Re: License No. TR-1
Docket No. 50-70

PROPOSED CHANGE NO. 1

GENERAL ELECTRIC TEST REACTOR

DOCKET NO. 50-70

GENERAL ELECTRIC TEST REACTOR CONTROL ROD ASSEMBLY MAR

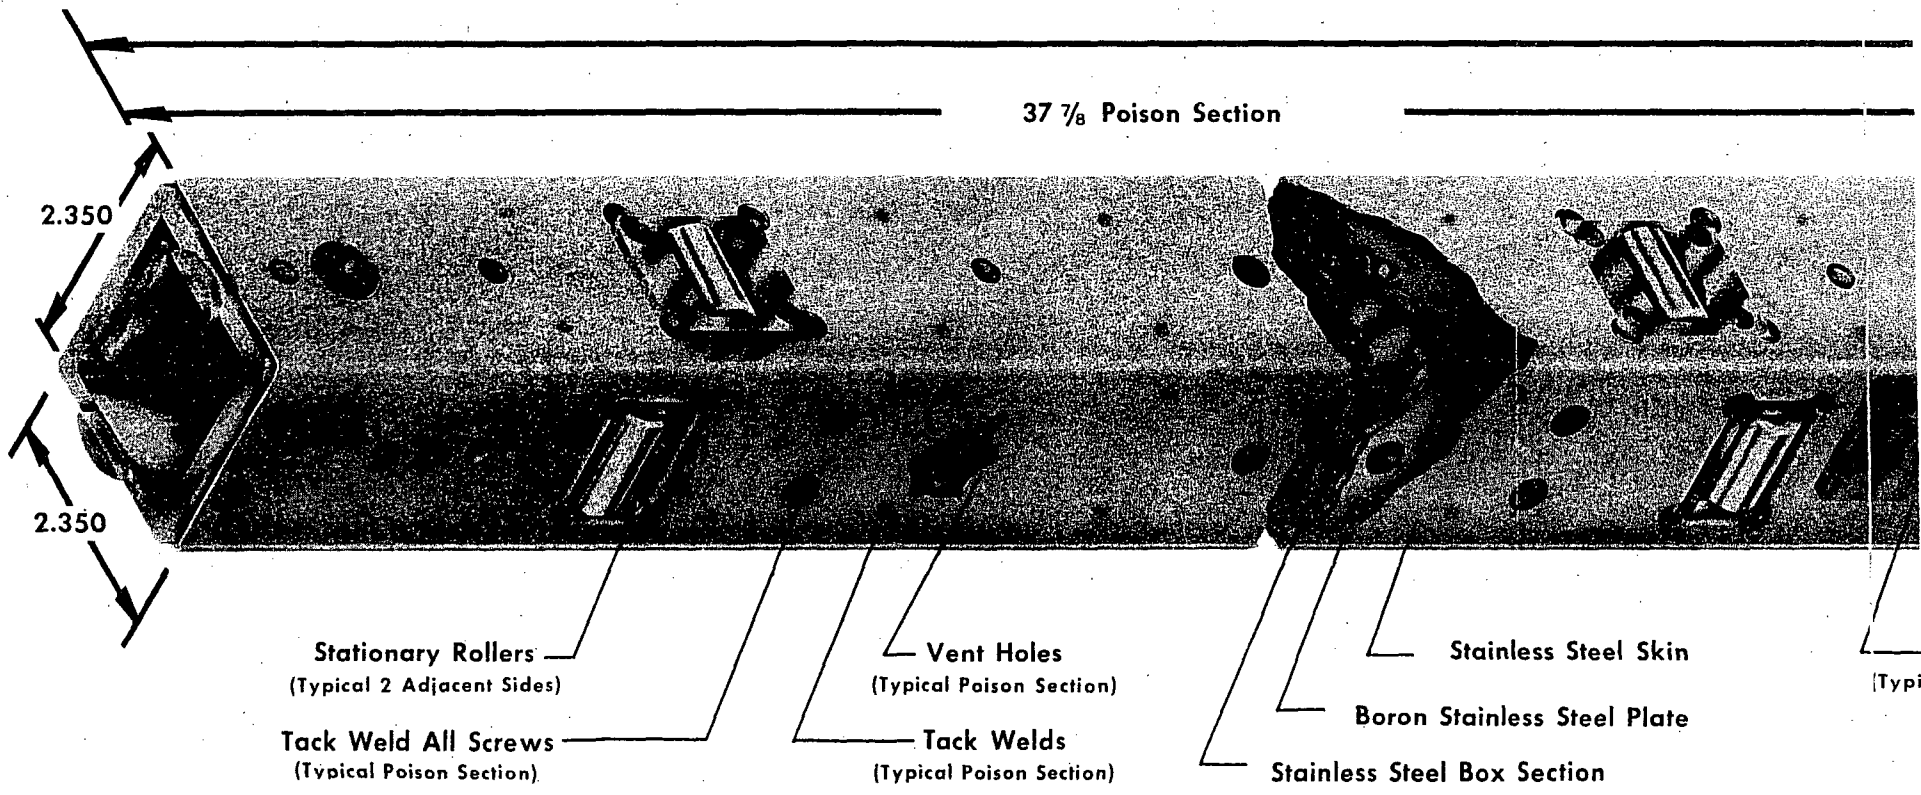
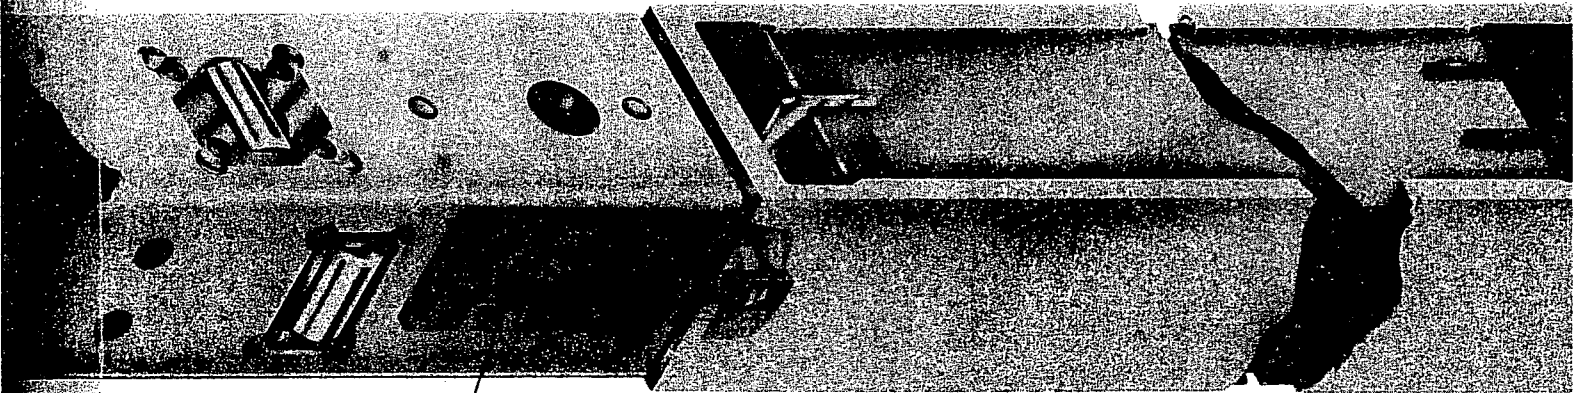
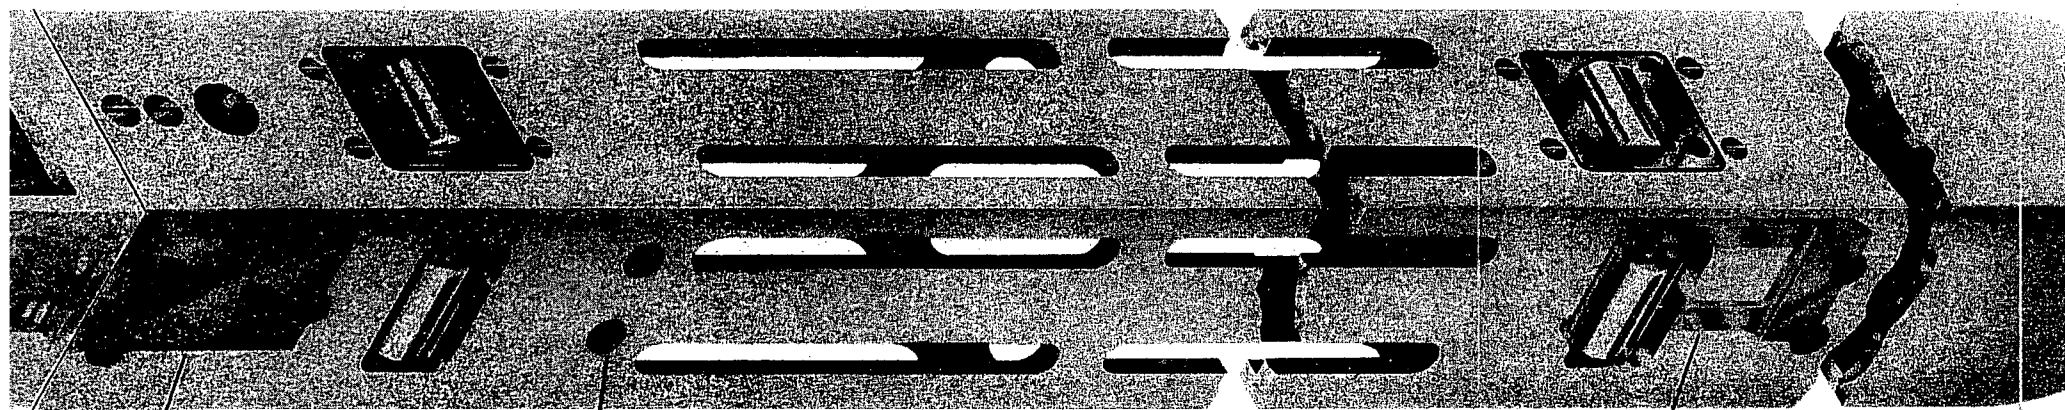
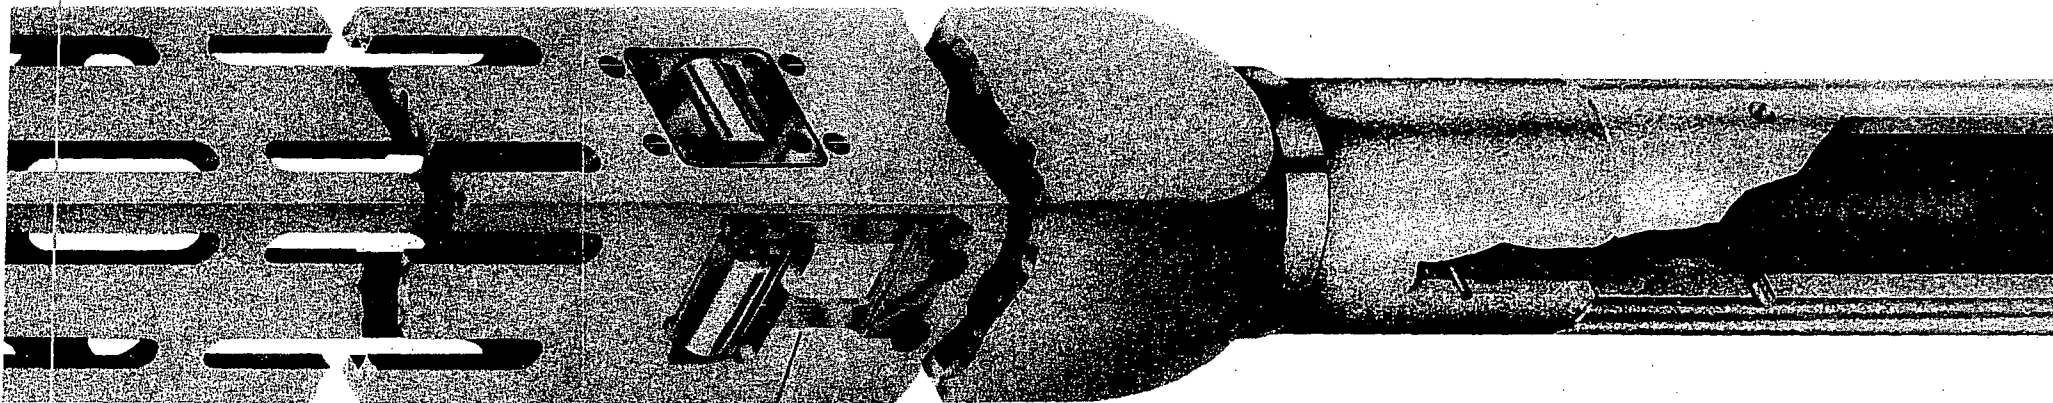
- 1) The existing boron-stainless steel in the poison section will be replaced by a "sandwich" type construction containing a structural stainless steel box covered with boron-stainless steel which in turn is covered with a stainless steel skin.
- 2) The latches which couple the poison section to the fuel follower section, and it to the shock absorber section will be replaced with a simplified spring latch. This latch is essentially identical to the latch currently being used in the ETR control rods. The new latch design does not require the "latch plate" in the fuel follower section so that two additional fuel bearing plates can be added to the fuel follower section.
- 3) The control rod rollers, both the fixed and the spring loaded types, will be replaced with rollers similar to those currently used in the ETR control rods.

Other than these three basic changes the rods are substantially similar to the existing rod design. The attached drawing shows the details of the proposed control rods (Mark II).

The control rod poison section is a square box approximately 2 3/8 inches square by 38 inches long. The configuration and dimensions of the redesigned poison section are identical to the present design. The center frame, which will provide support for the entire poison piece, is a solid box structure which will be fabricated of 3/16-inch-thick 304 stainless steel and then machined down to the required dimensions. The poison material is stainless steel containing approximately 1% boron enriched to 92% B-10. Strips of this material are fitted to the outside of the center frame and held in place by flat-head screws. A stainless steel "skin" 0.015 inch thick is wrapped around the poison plates and welded in place. As shown on the attached drawing, the flat-head screws used to attach the poison plates also hold the skin in place. There are weep holes in the frame and skin to vent the area around the poison material. As shown on the drawing, the flat-head screws are countersunk with the skin enclosed and tack-welded to the skin to prevent loosening of the screws. One difficulty experienced with Mark I control rods was the loss of poison material through the embrittlement of the boron-stainless steel material and subsequent cracking and chipping. The sandwich type construction which completely encloses the boron-steel will eliminate loss of poison material if cracking should occur.

New and improved latches will be used to couple the three control rod sections (poison, fuel, and shock absorber sections) into a single integral unit. The new latches are identical in principle to those currently used in the ETR control rods. They are made from one piece of spring material with dogs that engage holes in the mating part. The enlarged detail on the attached drawing shows the springs, dogs, and holes of a typical latch coupling. There are two spring latches each on the poison and shock absorber sections. The fuel follower section has holes on each end to accept the spring latches on the poison and shock sections respectively. Each spring latch also has a guard with protruding fingers around the latch spring and dog. The purposes of the guards are to protect the latch springs from possible mechanical damage during handling and to provide alignment of the rod sections once they are coupled together.

Latching of rod components is performed by butting one piece against the mating piece, which causes the spring latches to snap into place. Unlatching is performed by holding one section stationary and rotating the other section, thereby permitting the latch dogs to disengage from their holes (note beveled area to permit this action). Unlatching cannot occur in the reactor since all rod sections are held in alignment by the square guide tubes which contain the control rods. The latch springs, dogs and guards are made of Inconel X. As shown on the attached drawing the new latch does not require the actuating rods or latch plates which were part of the original design. The latch plate will

therefore be removed from the fuel follower section and two additional fuel bearing plates will be installed in its place. The fuel followers will now have sixteen fuel plates. Some of the existing fuel pieces will be modified to accept the new latch. These fuel pieces will have two non-fueled plates in place of the original latch plate. The roller design is similar to the original roller. The springs and method of attachment to the poison and shock section will be modified slightly to strengthen them and to reduce coolant hydraulic resistance. As shown on the attached drawing, only the poison and shock sections have rollers, and each has both the fixed and spring loaded roller types.

The GETR Technical Specifications, Section 1 of the Application, requires a change to permit operation with the redesigned fuel rod. In Table I-D, item number 12, delete the "Maximum" value (which is "14") and substitute therefor the value "16". In our opinion,
